EMERGENCY AIRWORTHINESS DIRECTIVE

Number: **G-2021-0010-E**

ATA 28 – Fuel –Cylinder Quick Shut-off Valve Mounting Flange – Inspection / Replacement

Figure 1: *CB437 Flanged Adaptors for Quick Shut-Off (QSO) valves*

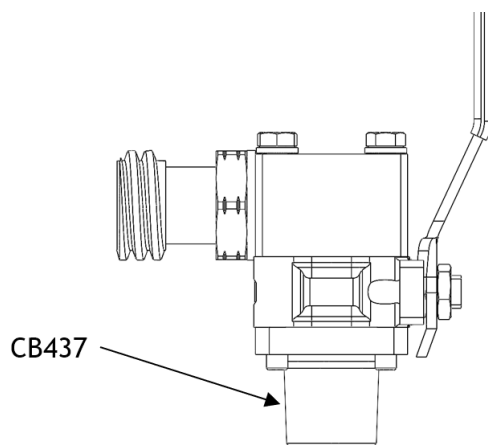
Certain Cameron Hot Air Balloon fuel cylinders are supplied with liquid offtakes that consist of a quarter turn ball valve mounted on a flanged adaptor (P/N CB437, see figure 1). Two recent batches of these adaptors have been manufactured with non-conforming (undersize) threads.

In certain cases, when the minimum sized adaptors are combined with cylinder bosses at maximum tolerance dimension and assembled to fuel cylinders, the thread can impinge (“bottom out”) on the cylinder boss. Although the required tightening torque value can be achieved at installation, the torque required to unscrew the flange could be below the minimum value. In extreme cases the adaptor may be unscrewed by hand.

4. From the effective date of this AD, do not install an affected part on any cylinder.
5. Within 4 months after the effective date of this AD, modify each cylinder by replacing the P/N CB437 issue F QSO flanged Adaptor, with a P/N CB437 issue G (or later issue) QSO flanged adaptor in accordance with the instructions of the SB, or by replacing the QSO valve assembly with a handwheel valve part No CB0824-0001 (this part has a Rego-type hose connection).
